**Tuesday July 10, 2018**  
**Medway Planning and Economic Development Board**  
**155 Village Street**  
**Medway, MA 02053**

**Public Hearing Continuation - Converting Technical Services Site Plan, 9 Trotter Drive**

**RE: Converting Technical Services (CTS) Site Plan**

***Major Site Plan Review Decision  
Converting Technical Services (CTS) – 9 Trotter Drive  
APPROVED with Waivers and Conditions***

**FILE NO:** 3583  
**GRADING & UTILITIES**  
**DATE:** MARCH 26, 2018  
**PLAN NUMBER:** 4 of 6  
**4**

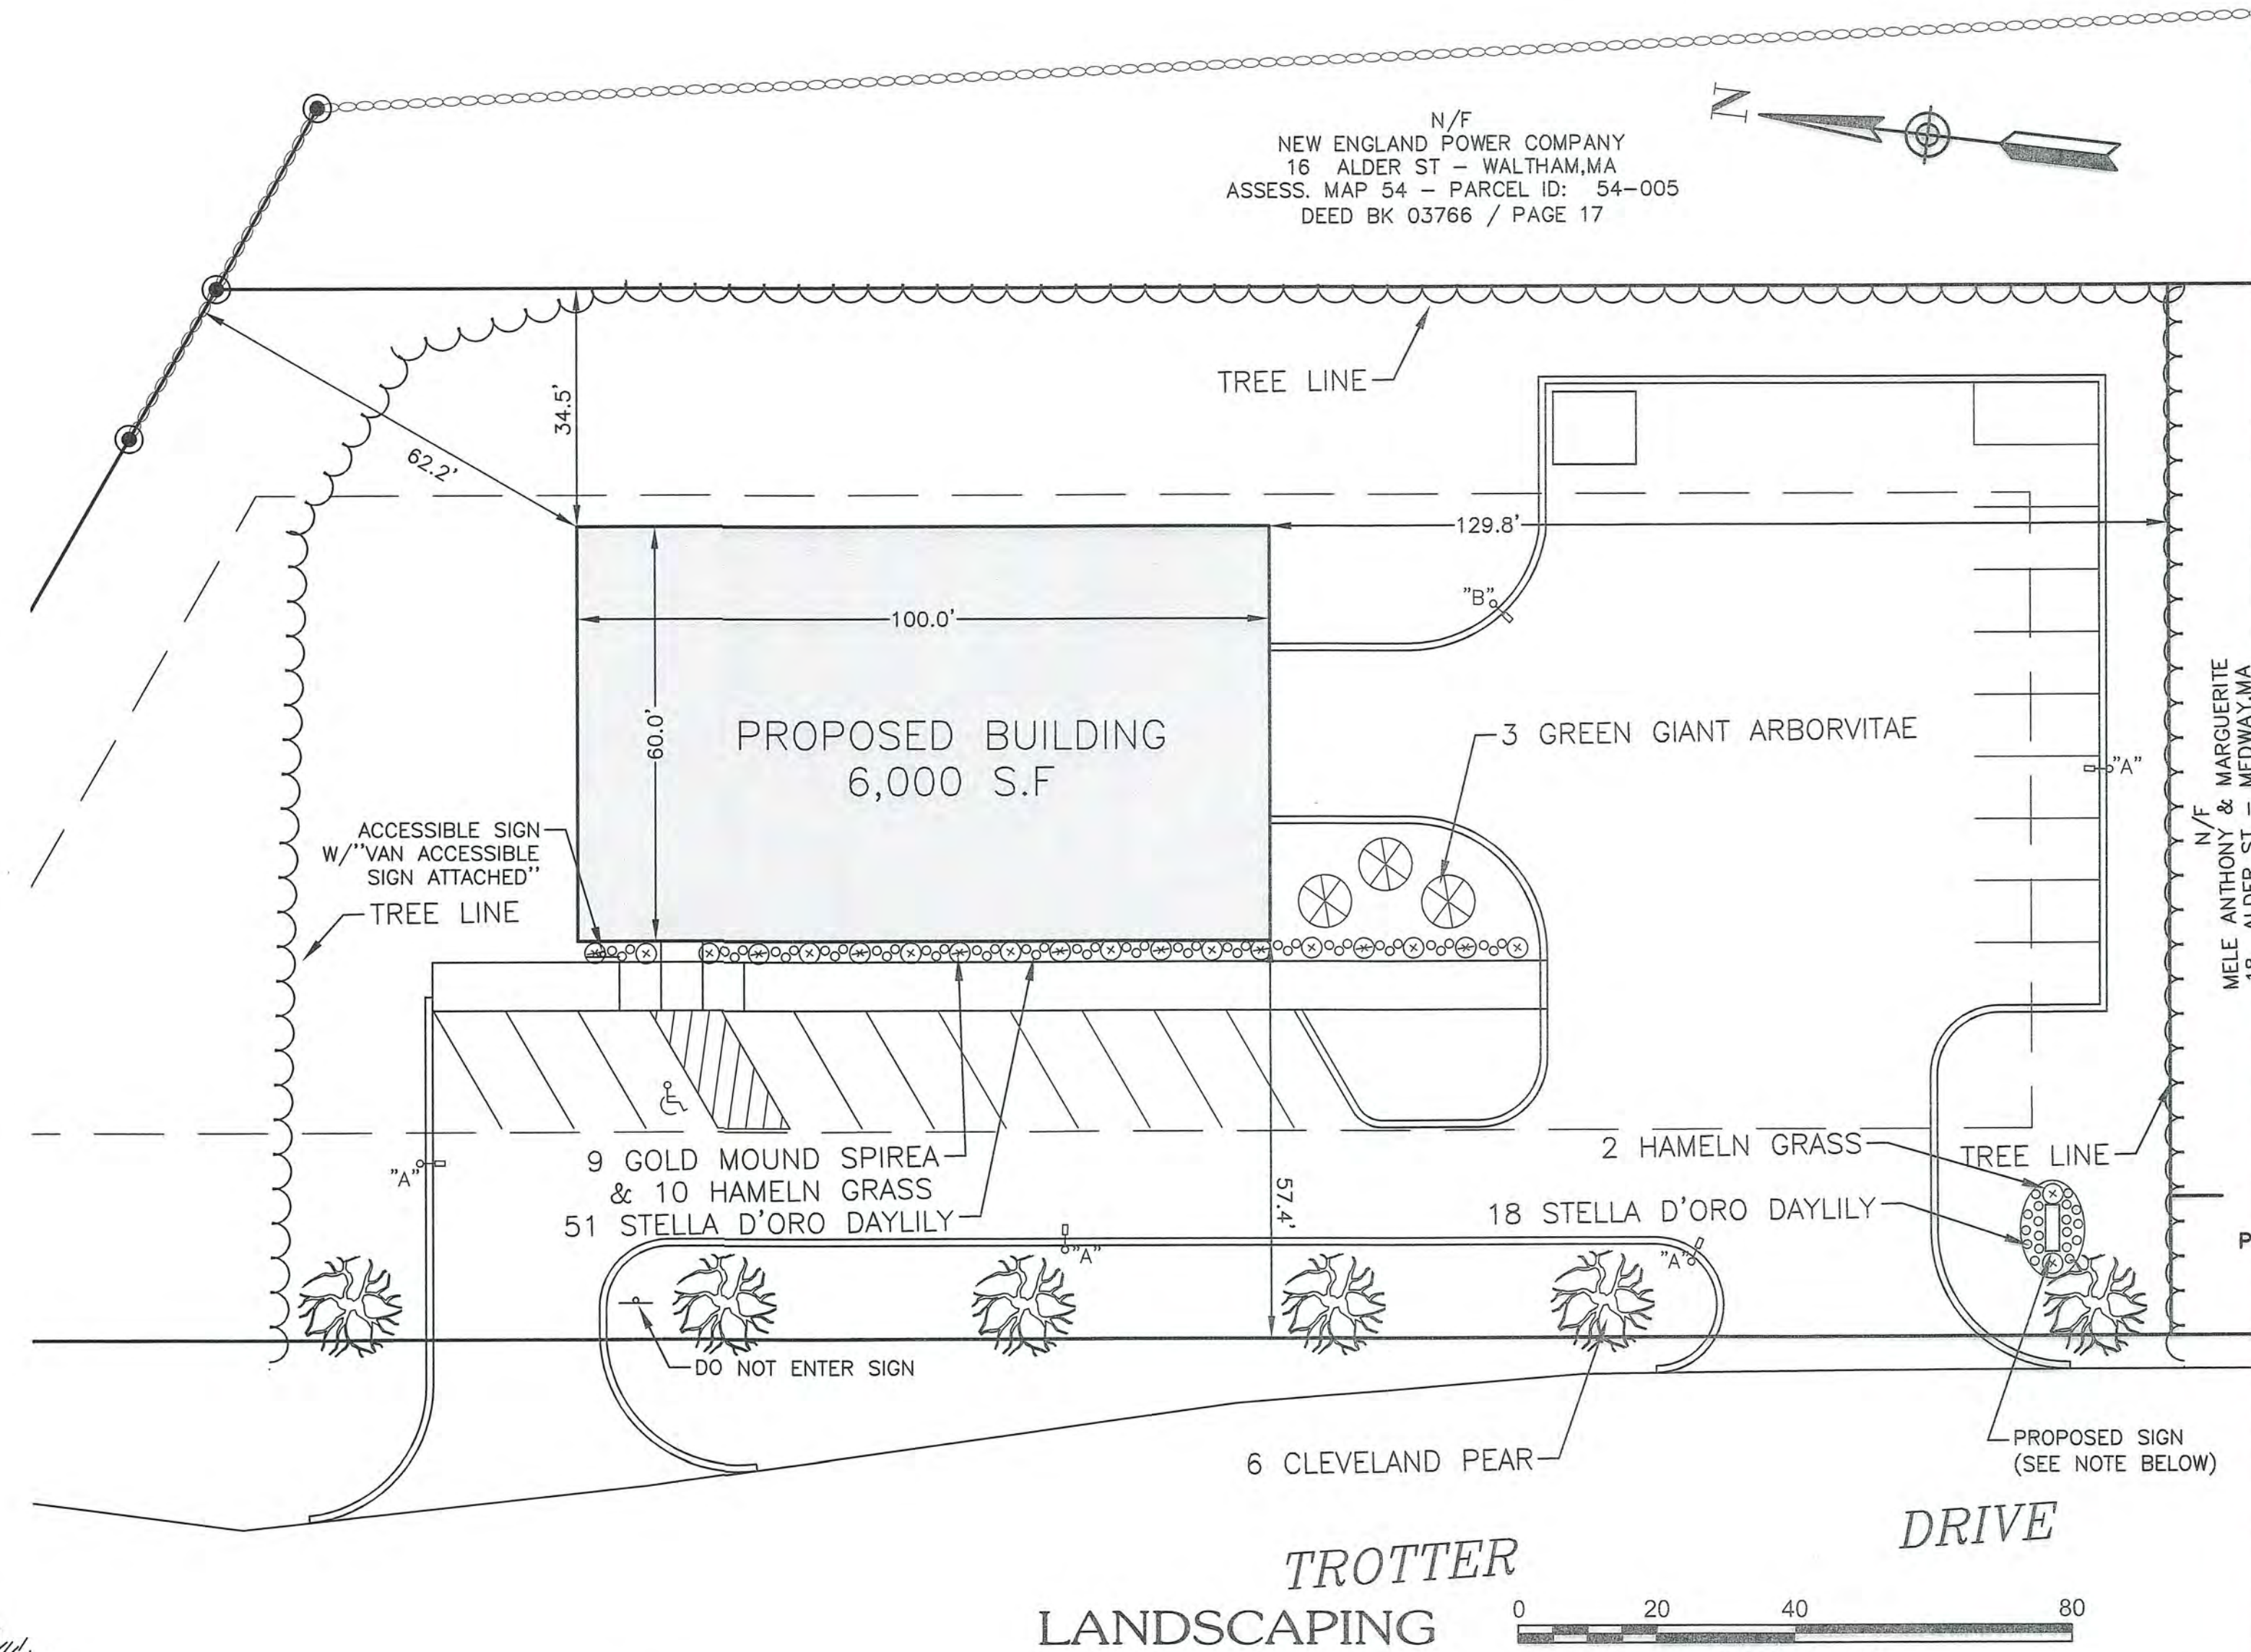
- “No cut” zone on northern property line. The distanced will be calculated from the building. Peter Bemis will provide that information to Susy
- Show direct connection to sewer manhole in Trotter Drive instead of through the adjacent property to the south.
- Remove item D regarding a sewer easement.

E NO: 3583  
 LIGHTING & LANDSCAPING  
 DATE: MARCH 26, 2018  
 AN NUMBER:  
 5 OF 6  
 5

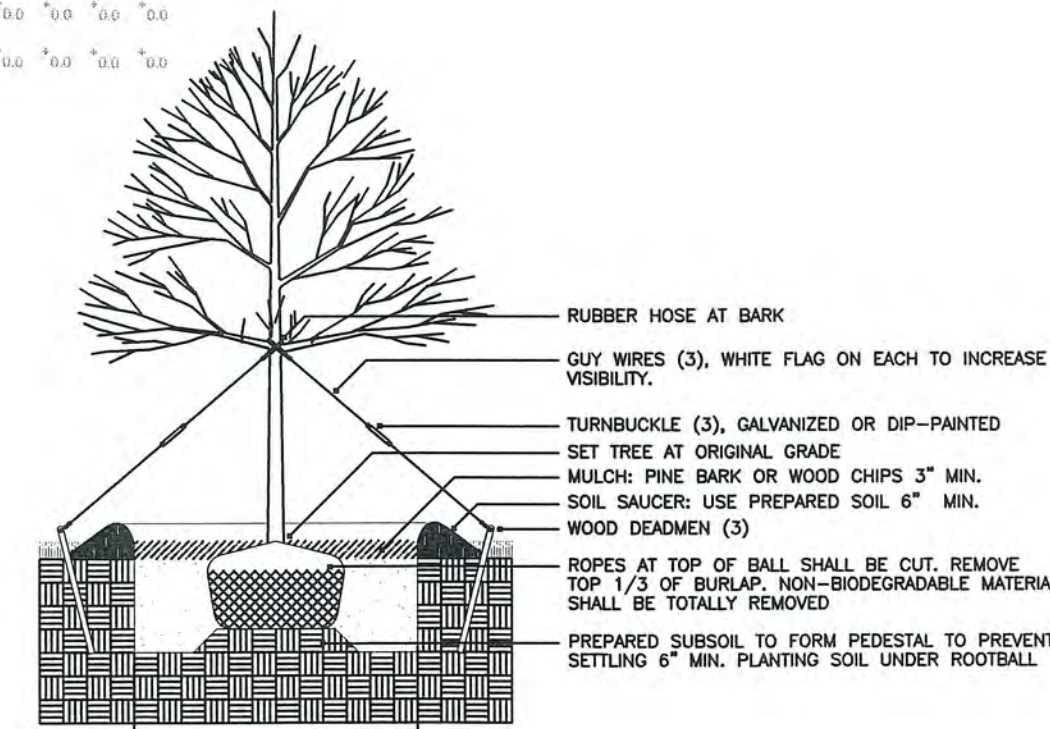
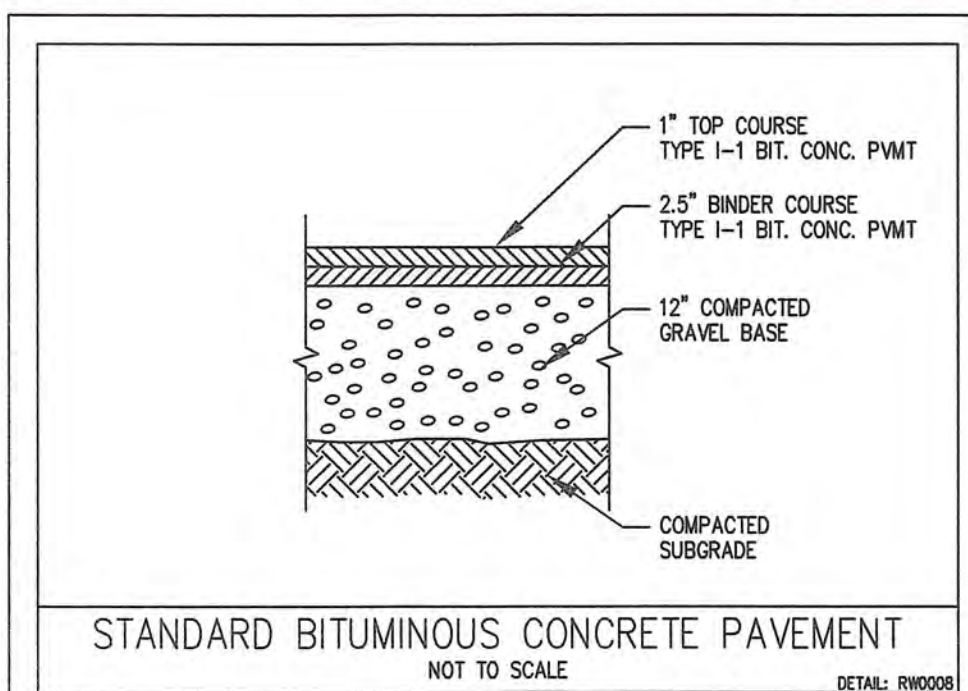
5. The plans show a location for a monument sign. The proposed dimensions of 20 feet per side comply with the maximum size requirements of 40 square feet total as well as the required setback of 10 feet. No height off the ground is shown but the maximum height is 6 feet. No

landscaping is shown at the base of the sign (and the sign is not shown on the landscape plan). The building elevations do not show a building sign. **The monument sign has been added to the landscape plan. The applicant states that no building sign is planned at this time but may be an option in the future.**

2. A ' NO CUT zone along the eastern and northern property lines
  3. Lighting details on Sheet 5 showing with no light trespass onto Trotter Drive.
  4. An additional line for Approval Date within the signature box area on all site plan sheets including the stormwater pollution prevention plan and building elevation drawings.
